Application for a New Premises Licence

McCAFFERTY'S BAR, 99 HIGH STREET, BRENTWOOD CM14 4RR

APPENDIX C

Representations

| Drawing: | PROPOSED LICENCE PLAN |

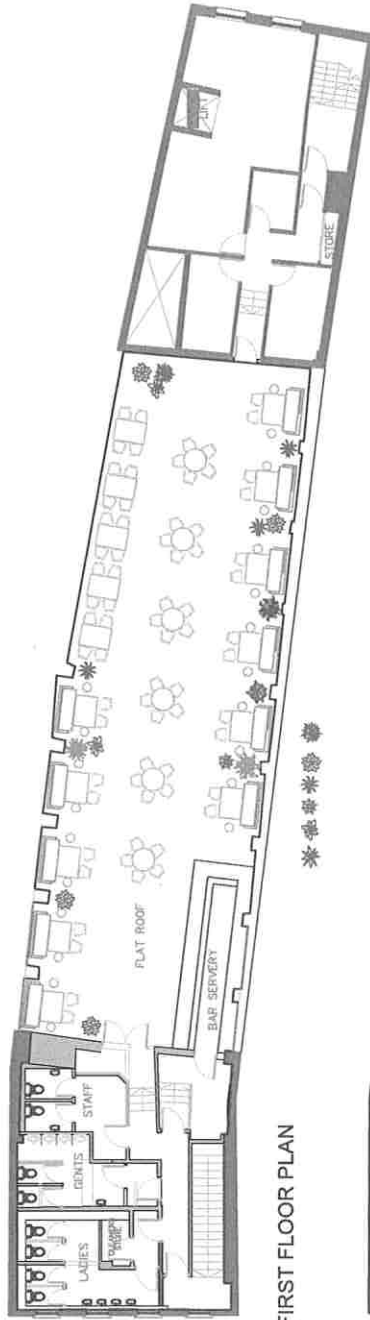
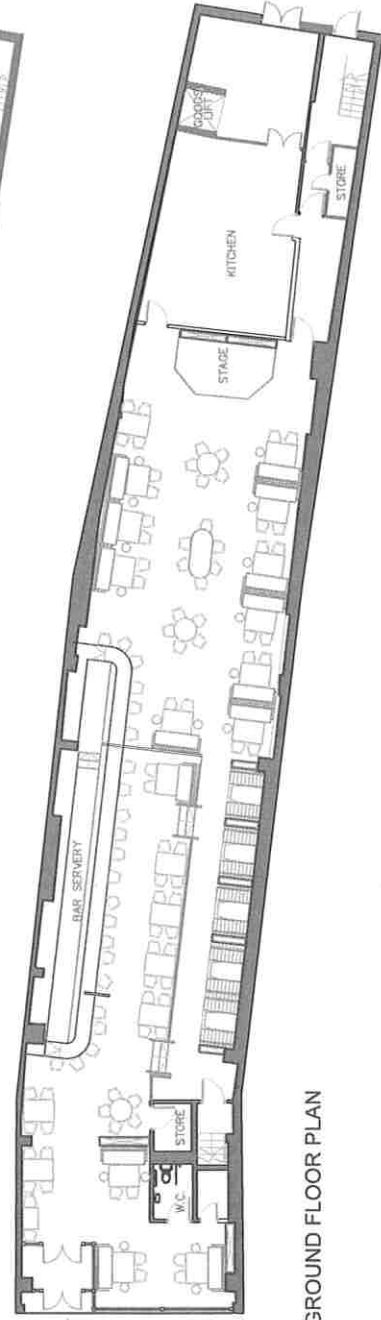
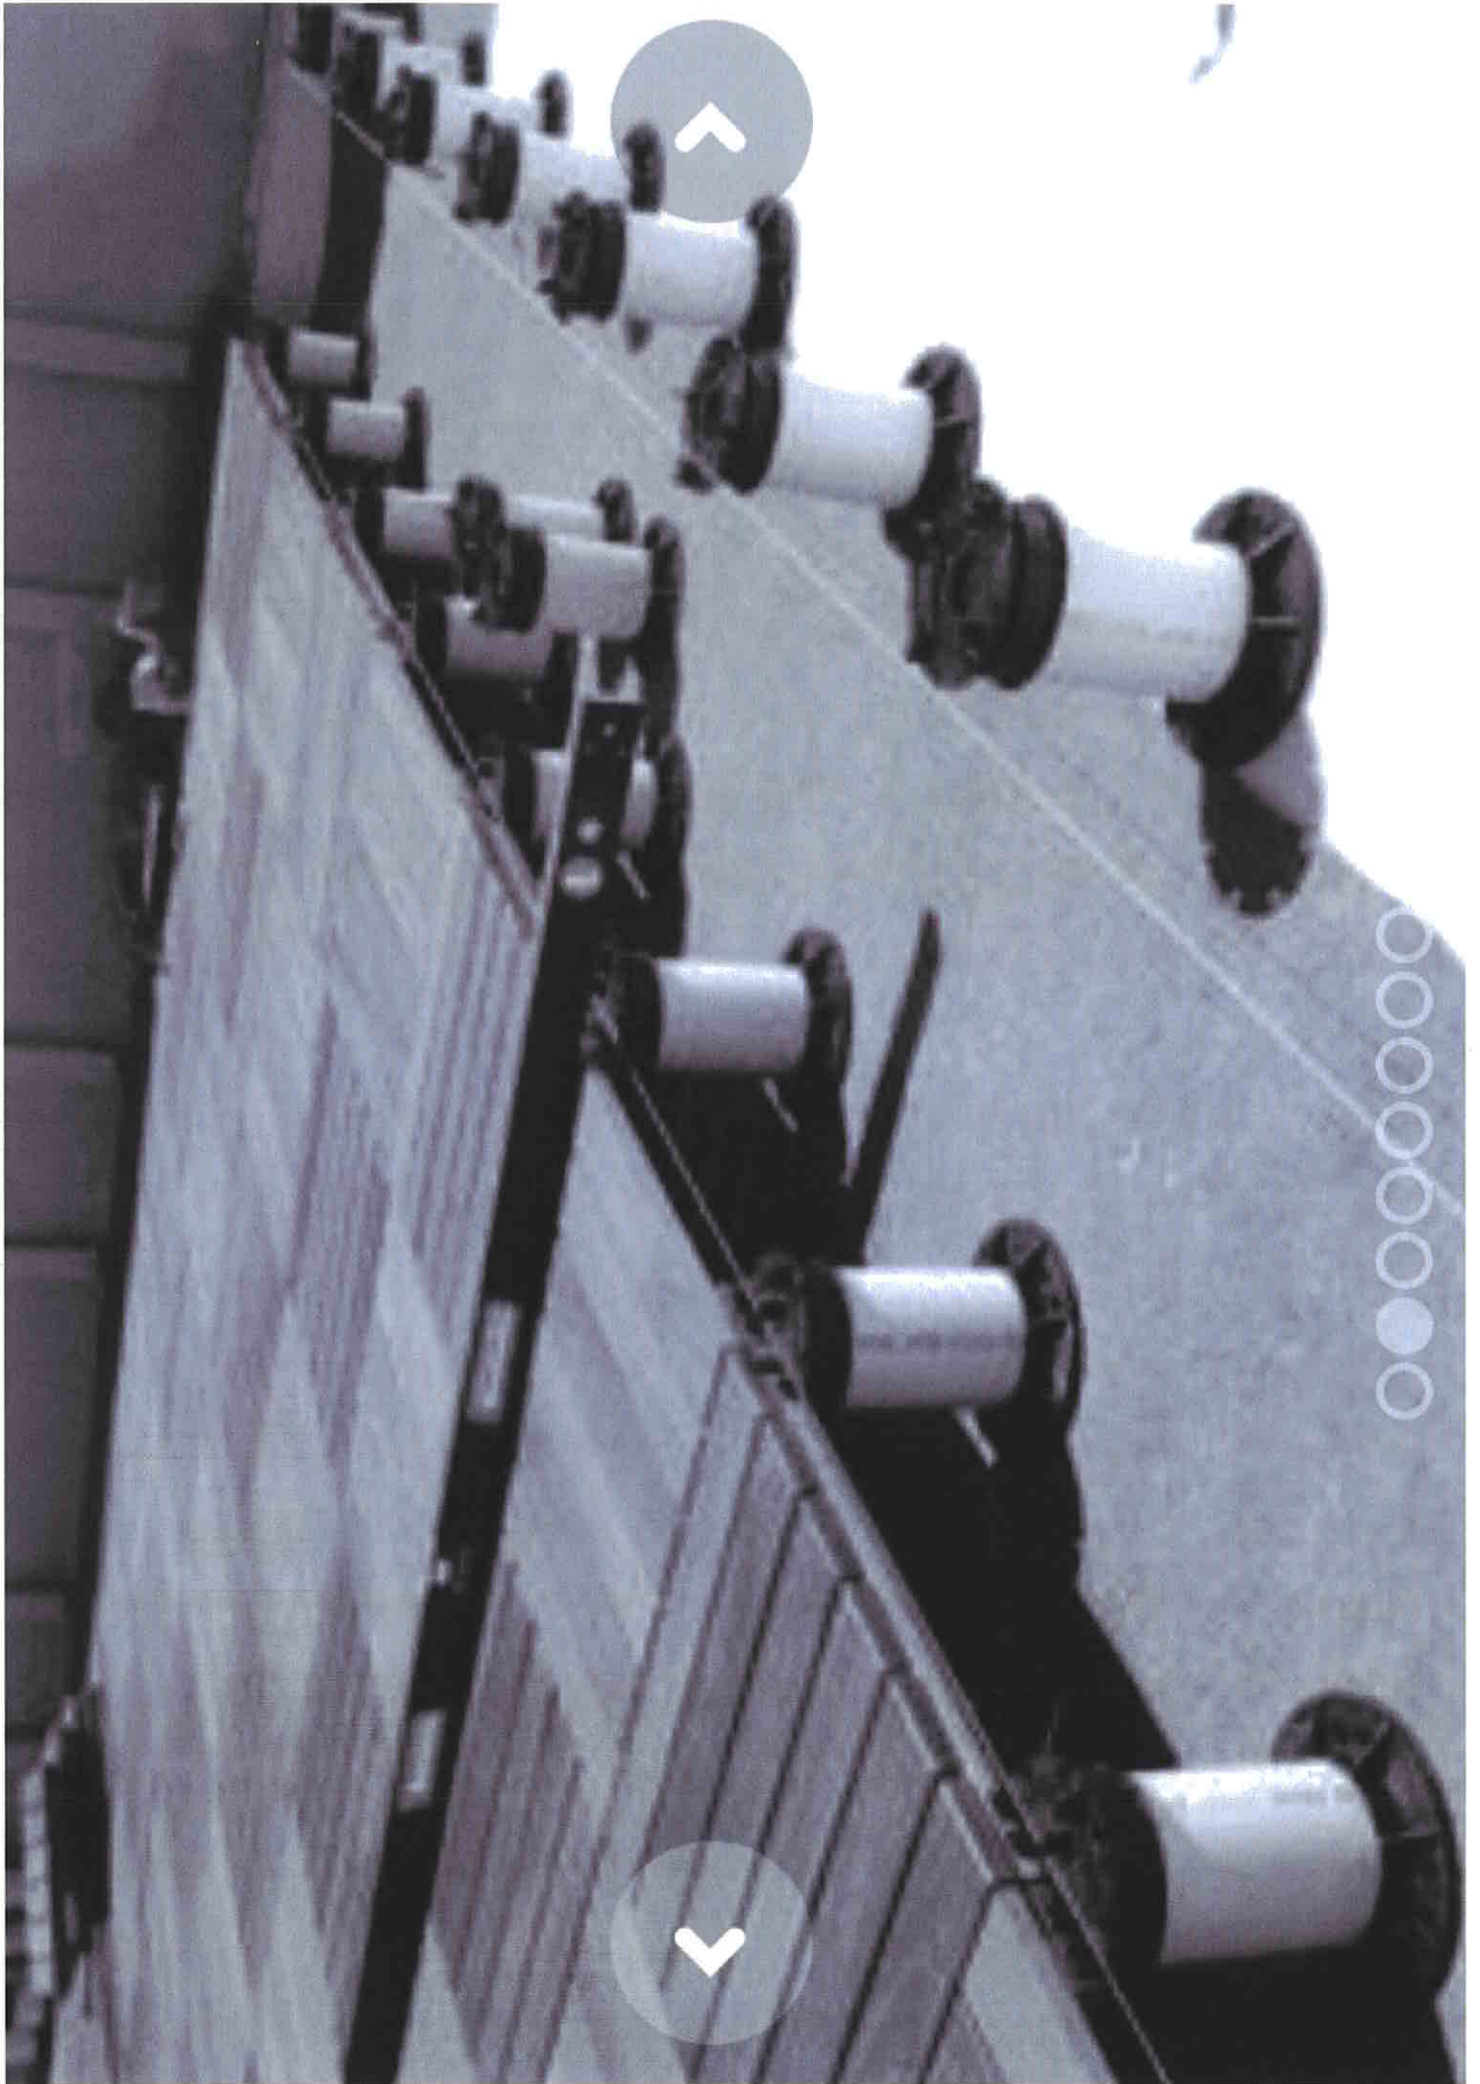
The plans submitted with the application do not reflect the on-site discussions in that the roof terrace has a bar servery indicated towards the staircase leading from the ground floor. During the meeting it was discussed that the bar would be located in a different position towards the rear staircase.

I request that we look to agree conditions regarding the use of the roof terrace area around my three points above. This area must be compliant with the smoke-free requirements should you wish smoking to be allowed. Furthermore the plans should reflect the proposals.

Separate to this response, there are revised design details regarding the retractable roof and the positioning of the bar servery.
